**ADDENDUM NO. 1
July 25, 2022**

**2022 Midfield Ramp Repair – Phase 1
Duluth International Airport (DLH)
Duluth, Minnesota
City of Duluth No. 22-4402
SEH No. DULAI 161944**

**Taxiway A Reconstruction – Phases 2 & 4
Duluth International Airport
Duluth, Minnesota
AIP No. 3-27-0024-074-2022
SP No. A6901-205
SEH No. DULAI 165102 & 167744**

SHEET TITLE
GRADING PLAN -
PHASES 2A & 2B

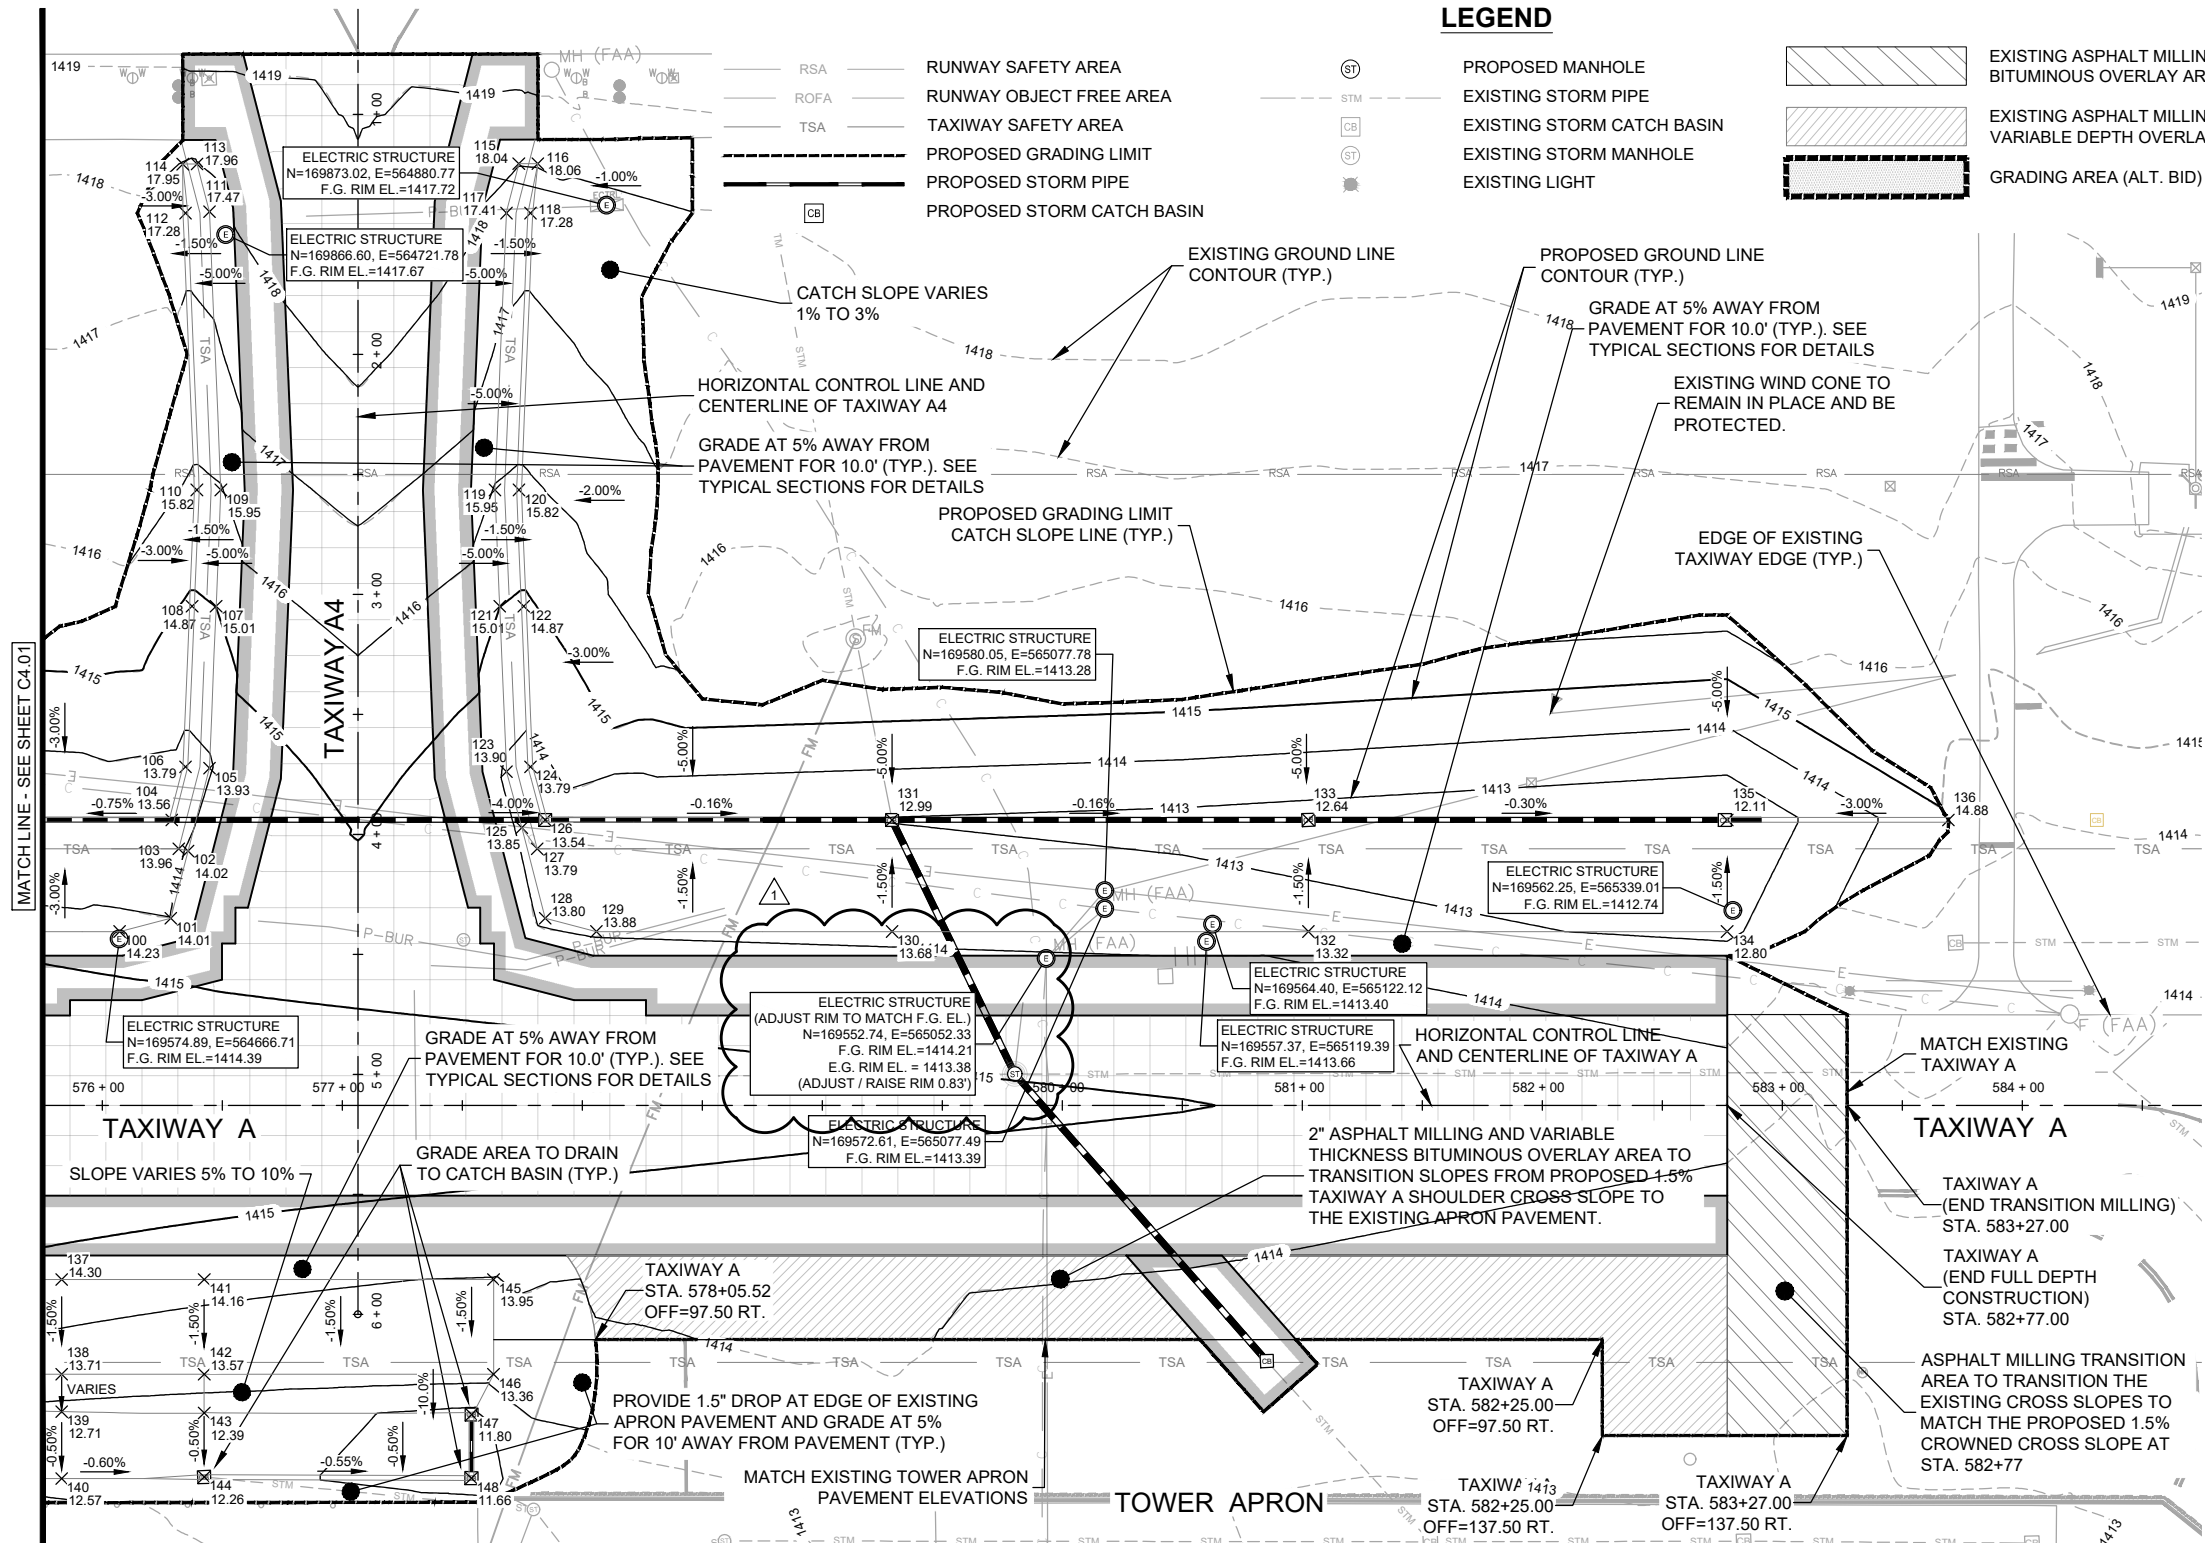
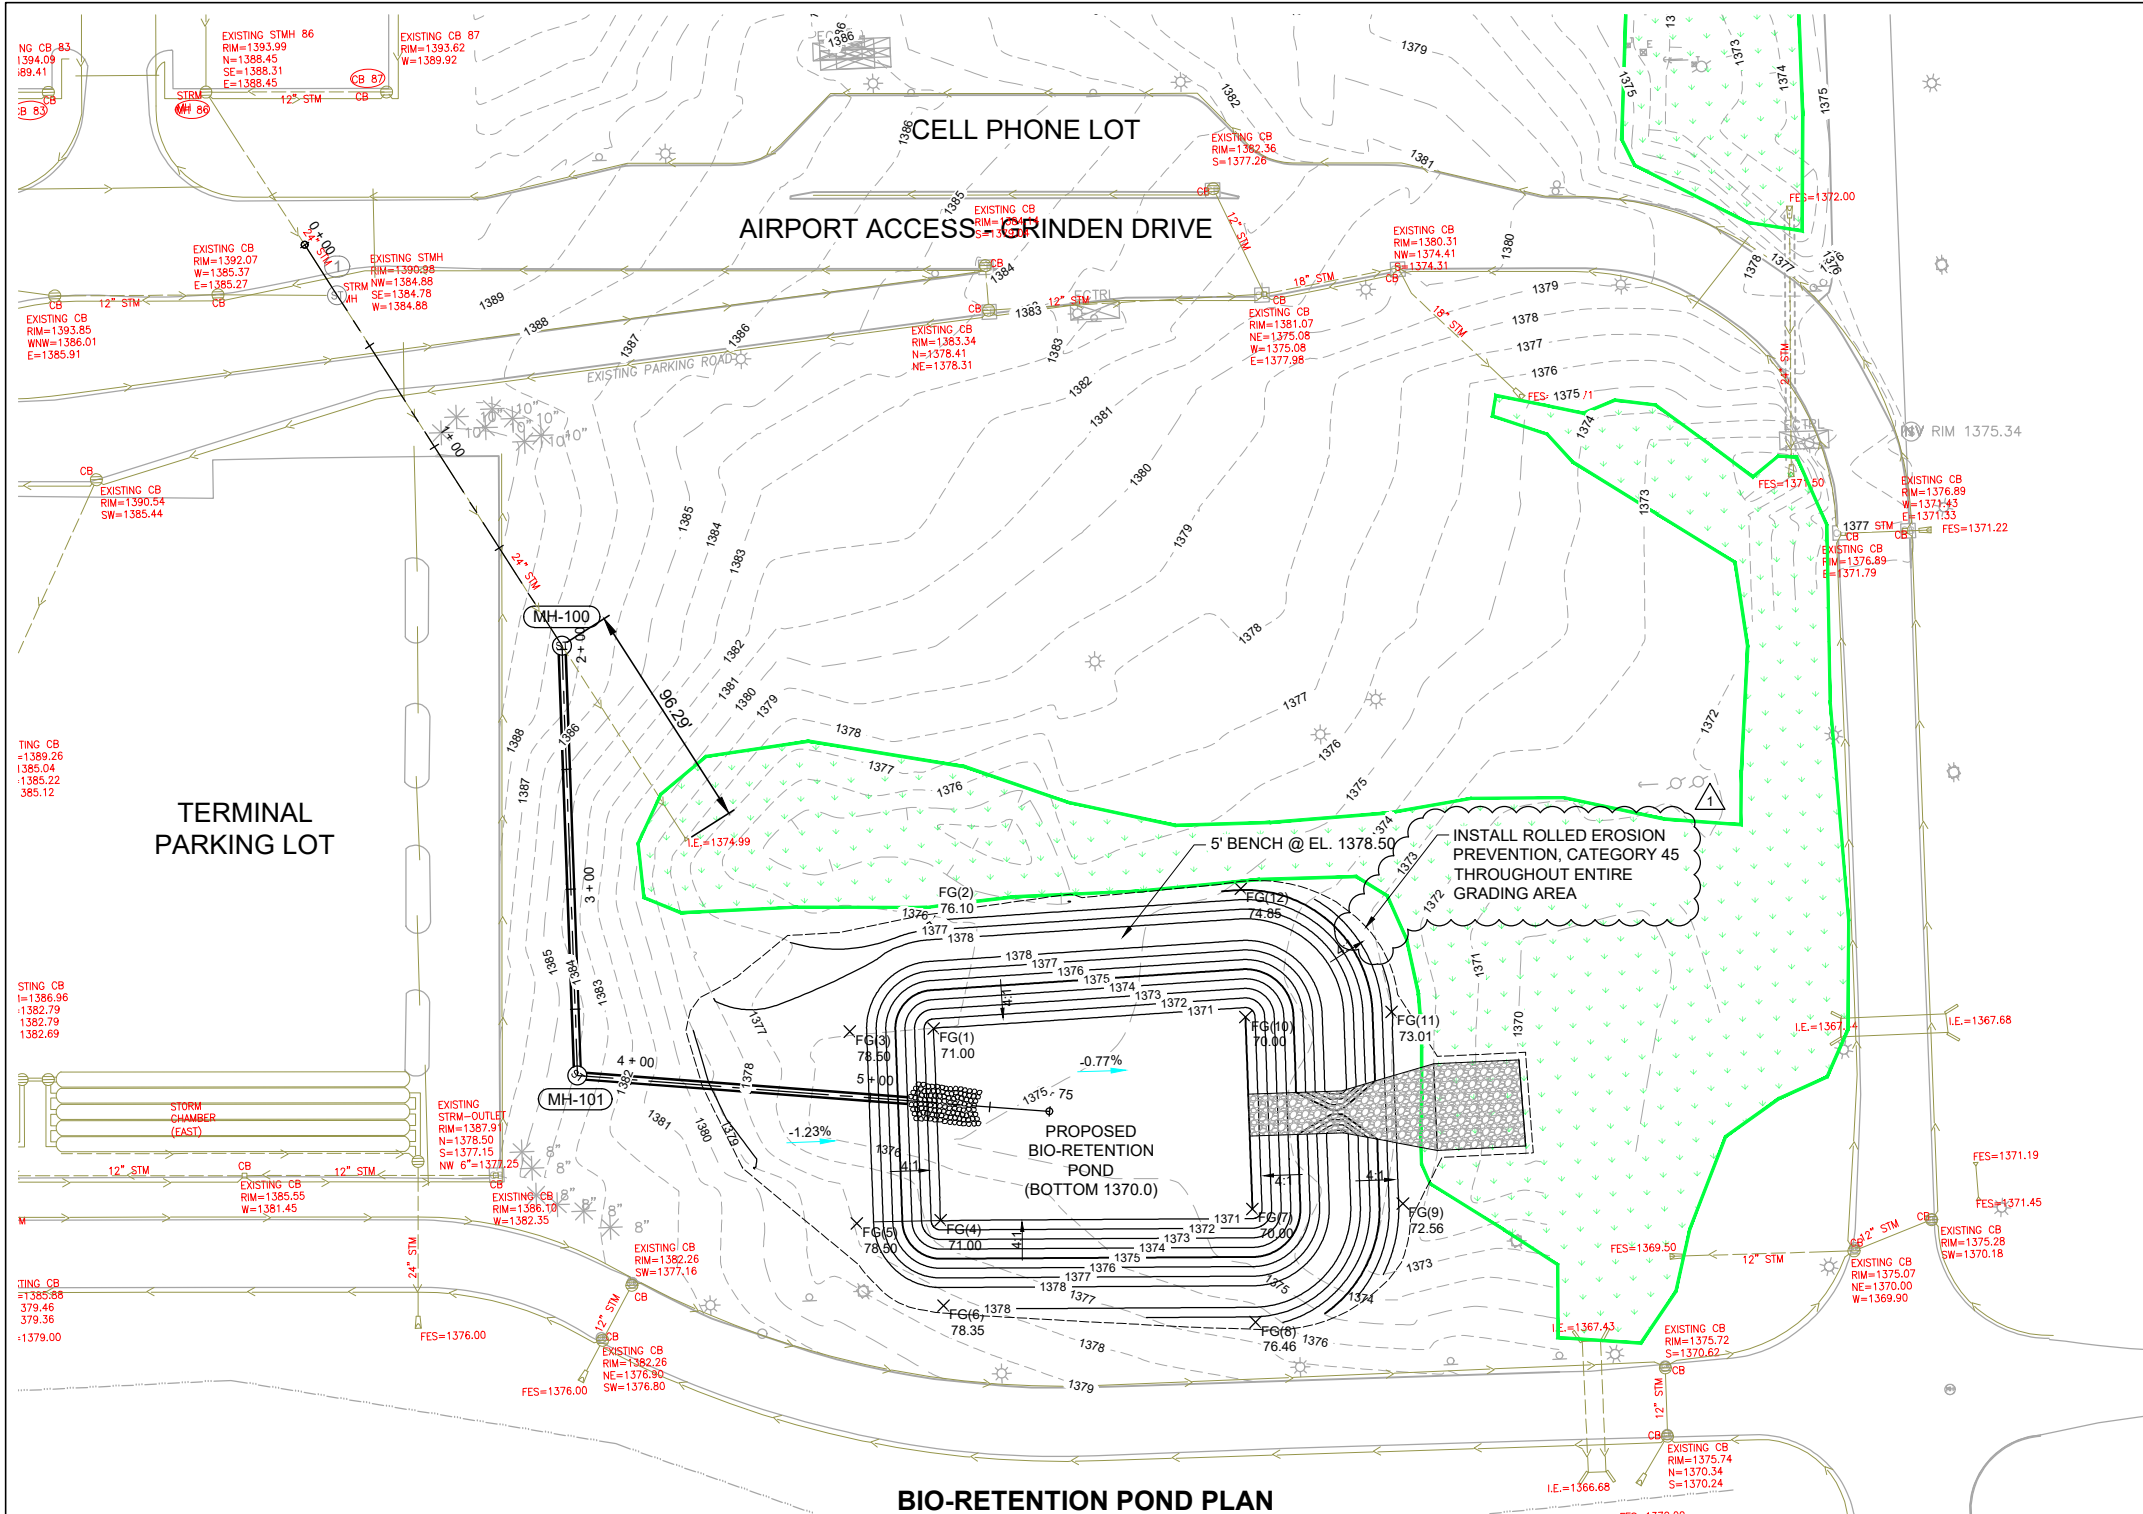
18. Drawing C3.07A PCC Joint Elevation Tables (SRE Apron) – Phase 4 – A new sheet has been added for the spot elevation tables for the SRE Apron VSR.
19. Drawing C4.02 Grading Plan Phases 2A & 2B – Additional information has been provided for the Existing FAA Electrical Manhole that needs to be adjusted.

SHEET TITLE
BIO-RETENTION
POND PLAN

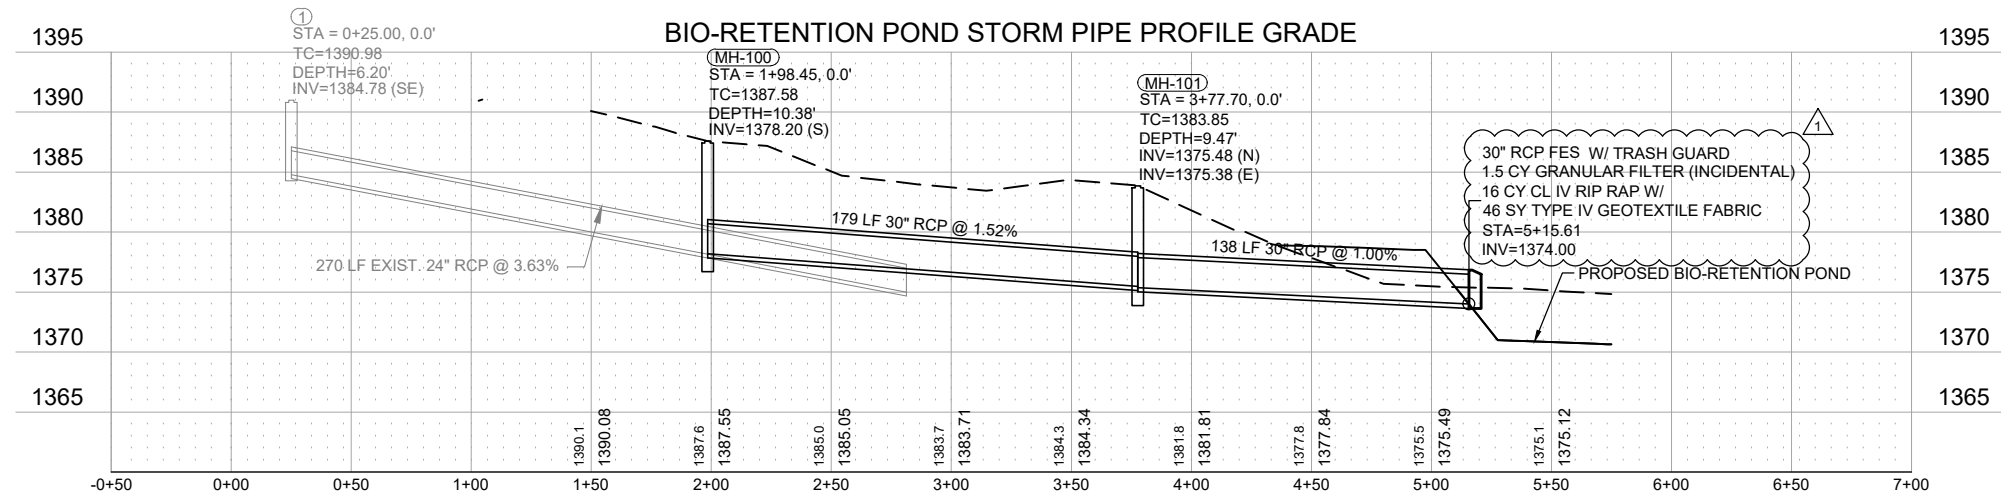
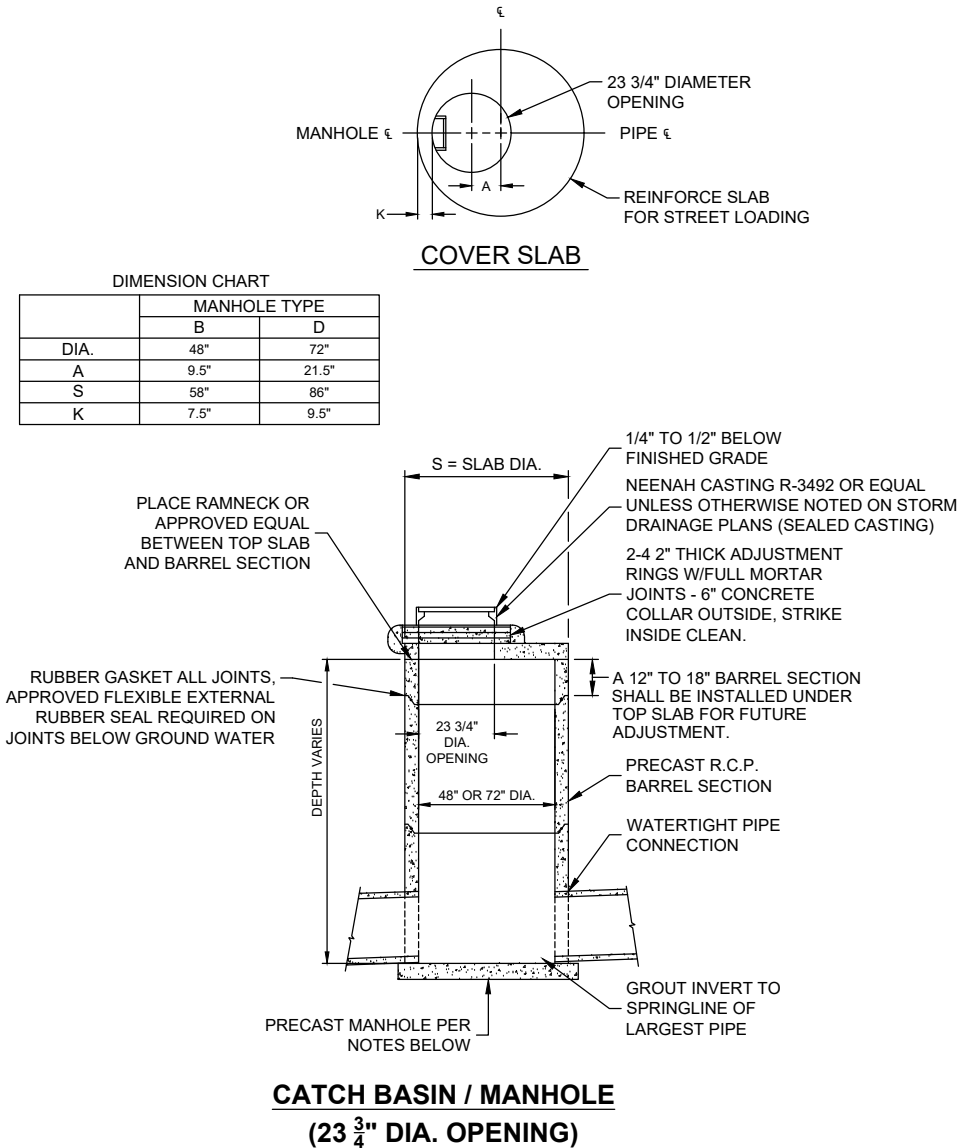
20. Drawing C4.06 Bio-Retention Pond Plan – An erosion control blanket has been added to the Bio-Retention Pond and a callout in the profile view has been updated.

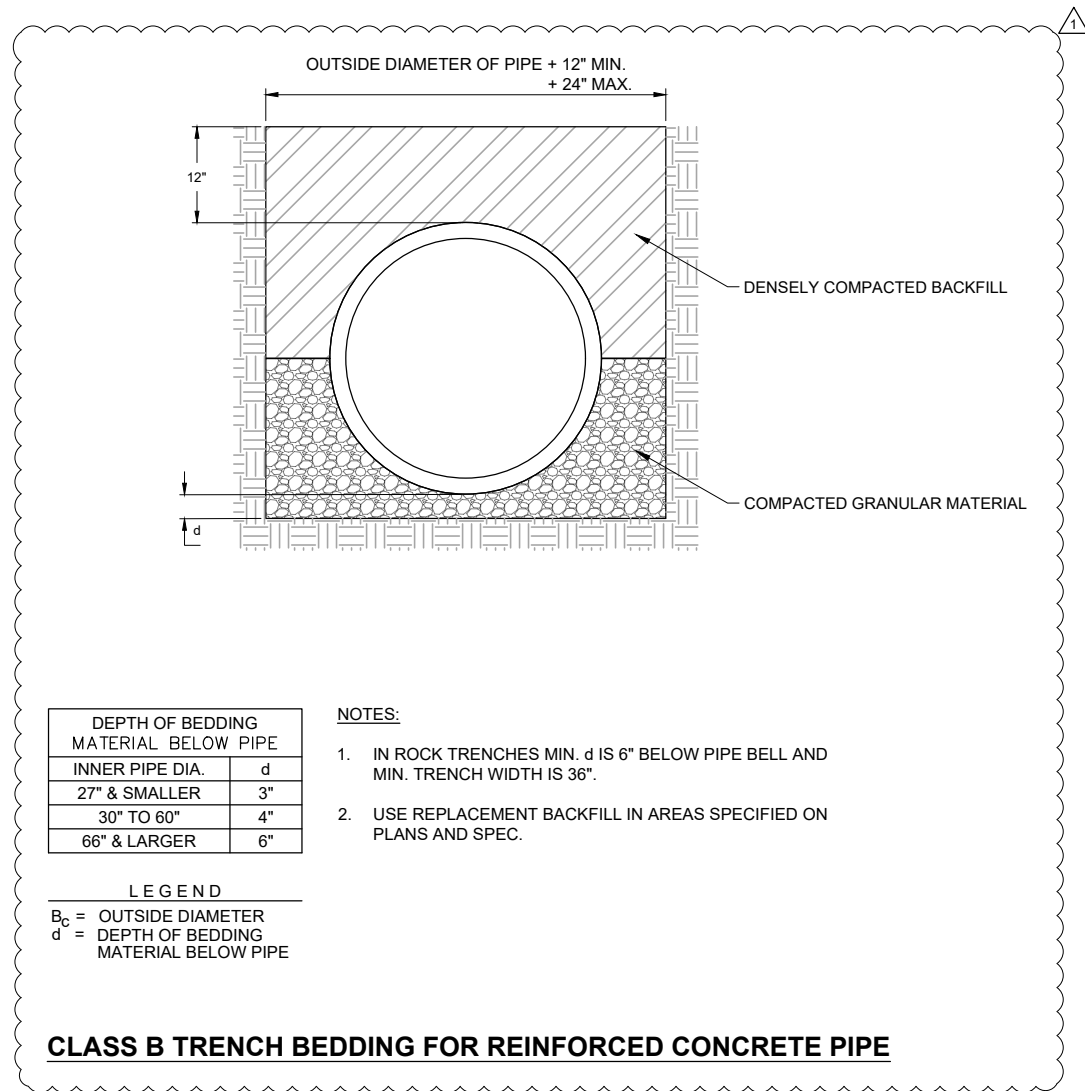
21. Drawing C5.11 Storm Sewer Details - Pipe Trench Detail updated to Class B Trench.
22. Drawing C7.02 Jointing Plan – Phase 4 - The jointing plan for the SRE Apron VSR has changed.
